Response to Queries raised by the Planning Department in relation to

2025/91279 Kenmore Drive, Cleckheaton

Rebuttal to Neighbour Objection – Planning Application [2025/70/91279/E]

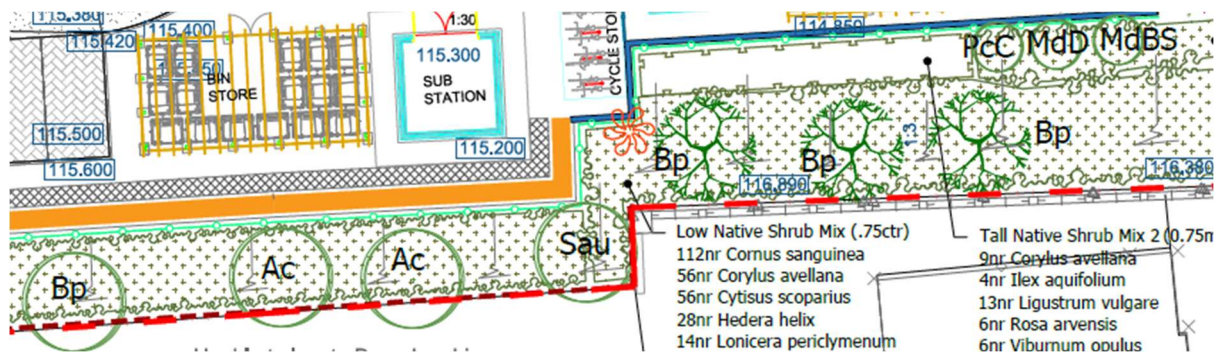
**Q4.** Your rebuttal on the comments made about removal of tree T19.

*The earlier approved 2022 site plan showed tree T19 as retained. T19 was felled on 27 February 2024 without permission, breaching the approved landscaping plan. The current layout (1101390) should accurately reflect the loss of T19;*

T19 (Hawthorne) did not have a TPO (Tree Preservation Order) Imposed and was considered a low impact value and whilst it was originally acknowledged on the masterplan as to be retained, upon completion of the muck shifting and ground clearance to that area it was found that the tree was rotting and approximately 2m in height to the base from the proposed ground level.

The architect was advised to include additional trees to replace this on the 26<sup>th</sup> of February prior to its subsequent removal.

It should be acknowledged that yes T19 was removed but there are replacement trees planned around the site and in consideration of the neighbouring properties there are further additions by way of more trees and high and low plantings

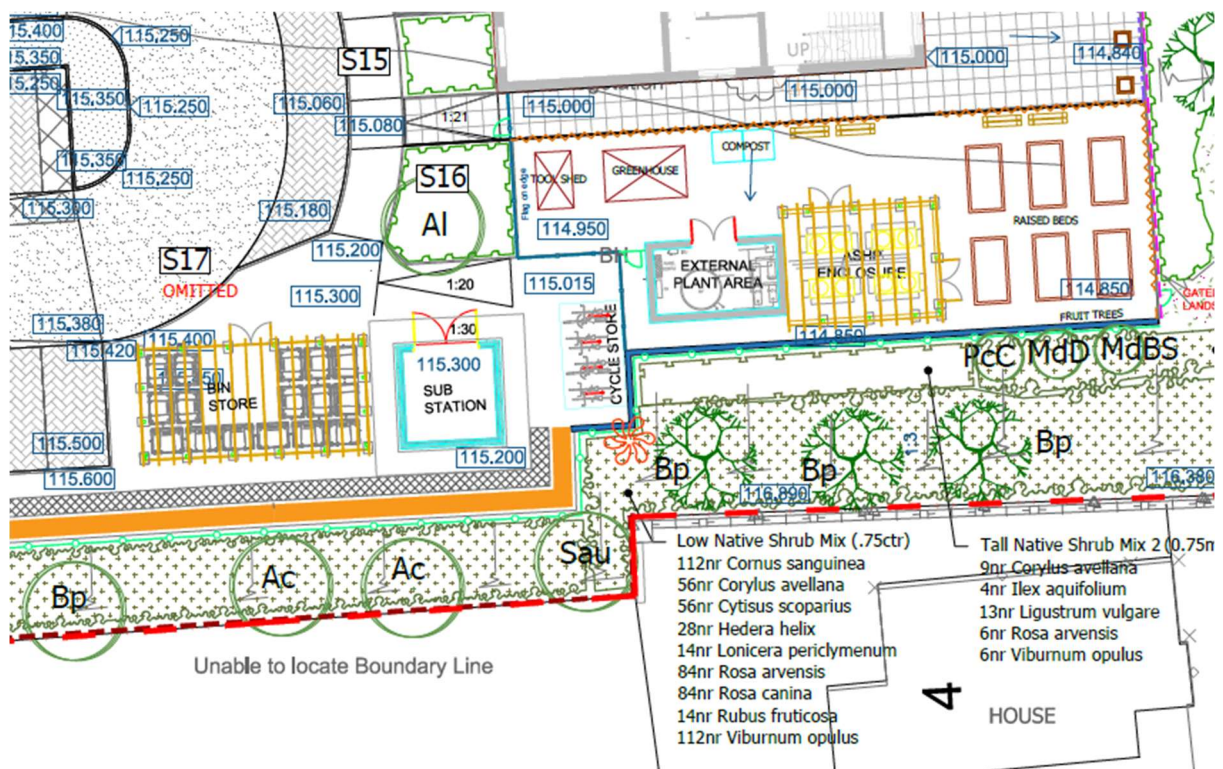
**Q5.** Further to your request, I have removed the new Landscape Scheme (which shows the old bin store) from the website, however subject to whether the above matters can be satisfactorily concluded, we will require a new plan.

This has been revised and issued to the planning department on the 12<sup>th</sup> of September 2025 ready for uploading to 2025/70/91279/E at the next opportunity the planning department has.

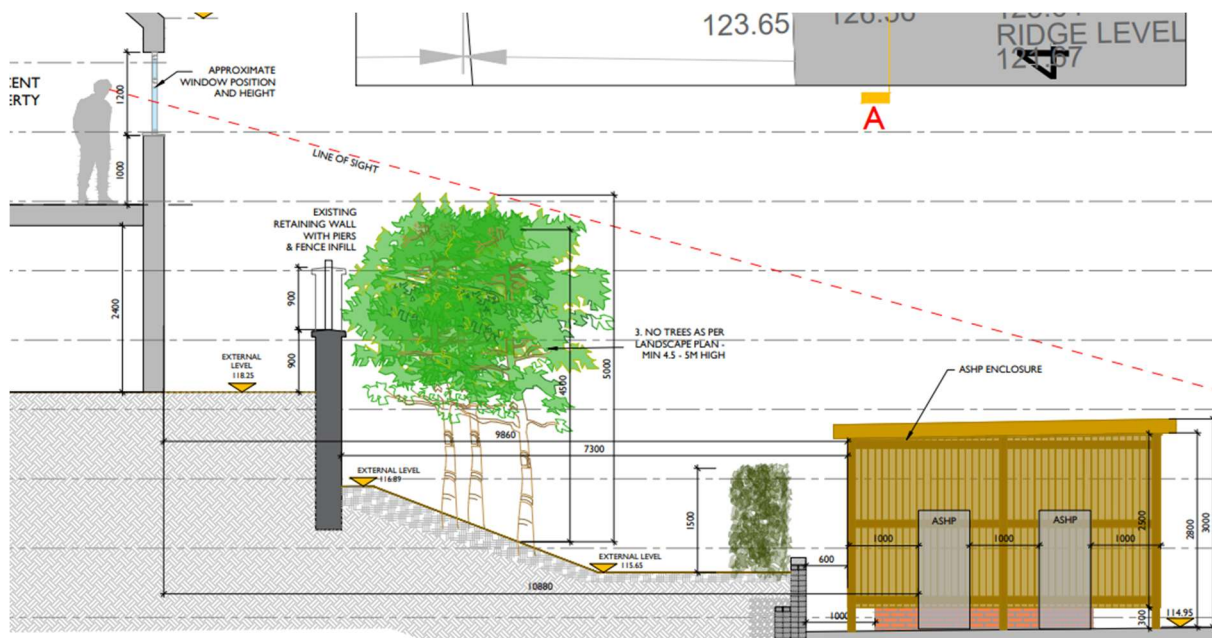
**The proposed location for this new infrastructure was originally designated for a Growing Area, Compost Bay, and Tool Shed, as shown in the original site plan submitted with the approved application. This shift from shared green amenity space to industrial mechanical plant represents a fundamental change in character and intent**

The design intent still allows for the same aesthetics. Visually the only additional items visible in part, is the featheredge fence and the top of the pergola.
